**TAC: Roofing**

**This document created by the Florida Department of Business and Professional Regulation -  
850-487-1824**

Total Mods for **Roofing** in **Pending Review** : 113

**Figure 1 – Cleated Eave Edge Metal System**

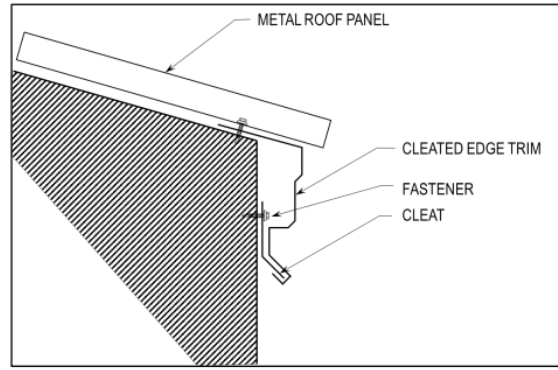
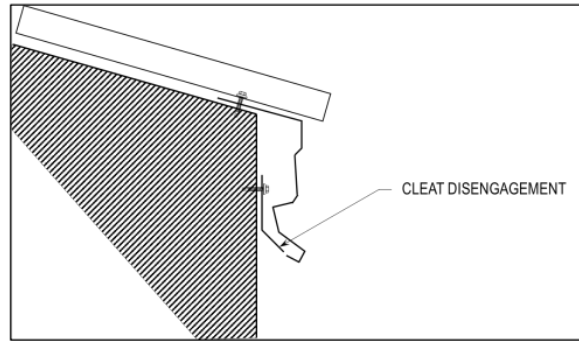
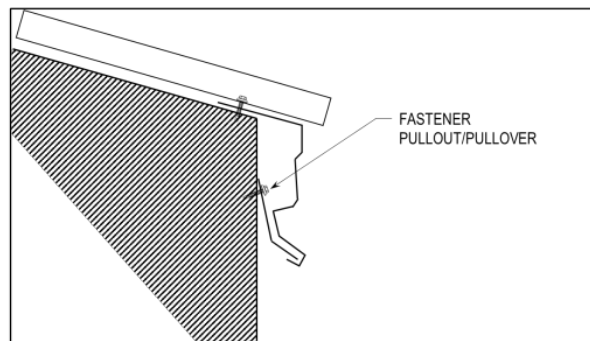
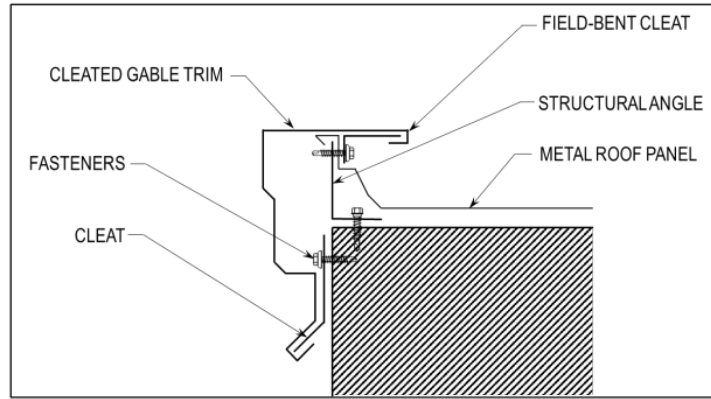
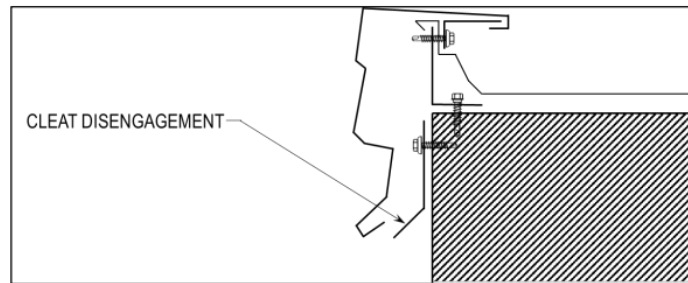
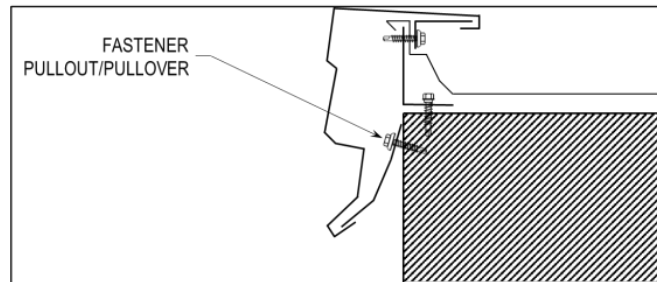
- Where a multi-piece edge trim assembly incorporating cleats deformed enough to disengage from the cleat. (Figures 1a and 2a)
- Where the metal edge trim assembly was fastened to a non-metal substrate such as wood or masonry, leaving to question the appropriateness of the fastener used since it would often not be provided by the edge system manufacturer for non-metal substrates. (Figures 1b and 2b)

These tendencies were also observed by FEMA in their Mitigation Assessment Team Report for Hurricane Ian. (<https://tinyurl.com/mmr5bxju>) Section 6.3 of this report includes Conclusion FL-10, as shown in Figure 3, recommending that FEMA support industry stakeholders in supporting code change proposals to requiring testing of hip and ridge roof coverings. (FEMA P-2342, Page 6-9)

**Figure 1 – Cleated Eave Edge Metal System**

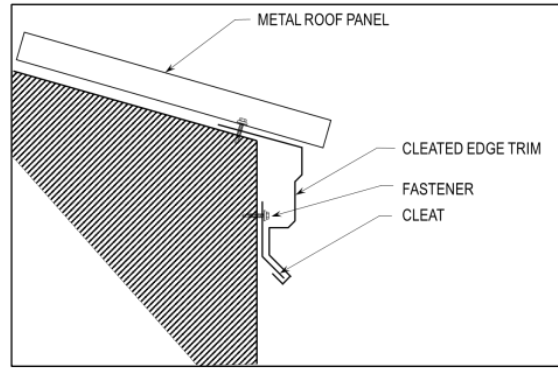
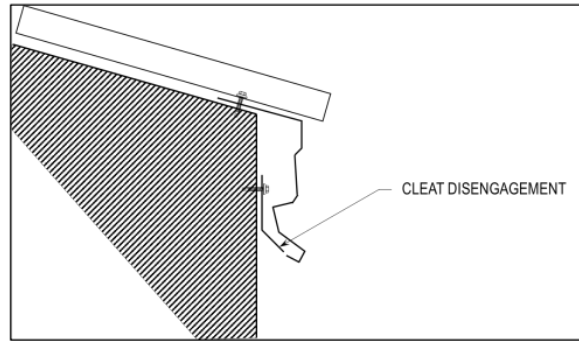
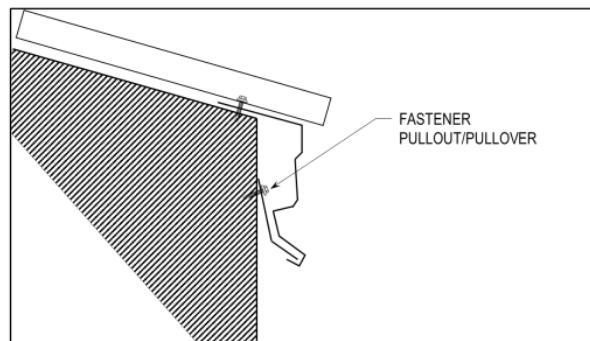
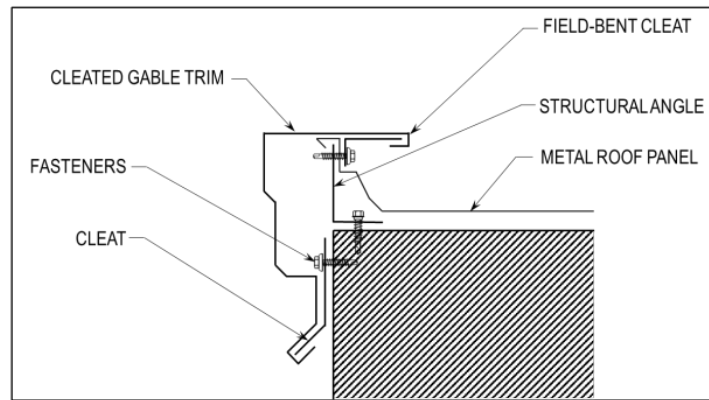
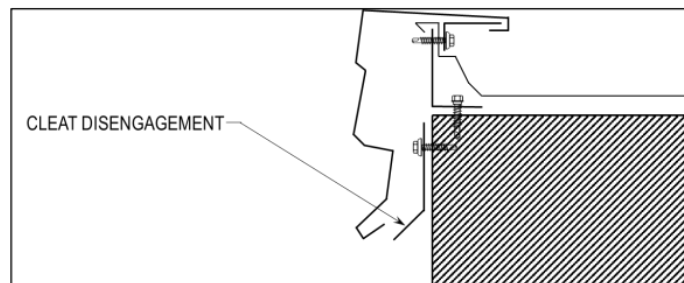
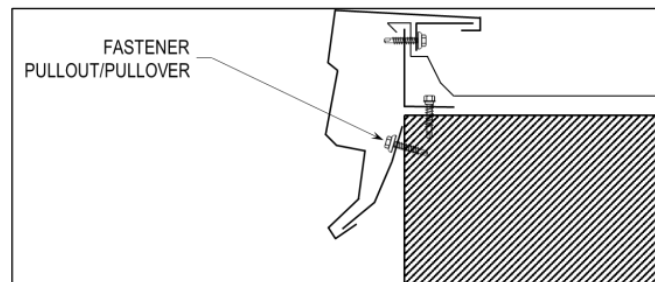
- Where a multi-piece edge trim assembly incorporating cleats deformed enough to disengage from the cleat. (Figures 1a and 2a)
- Where the metal edge trim assembly was fastened to a non-metal substrate such as wood or masonry, leaving to question the appropriateness of the fastener used since it would often not be provided by the edge system manufacturer for non-metal substrates. (Figures 1b and 2b)

These tendencies were also observed by FEMA in their Mitigation Assessment Team Report for Hurricane Ian. (<https://tinyurl.com/mmr5bxju>) Section 6.3 of this report includes Conclusion FL-10, as shown in Figure 3, recommending that FEMA support industry stakeholders in supporting code change proposals to requiring testing of hip and ridge roof coverings. (FEMA P-2342, Page 6-9)
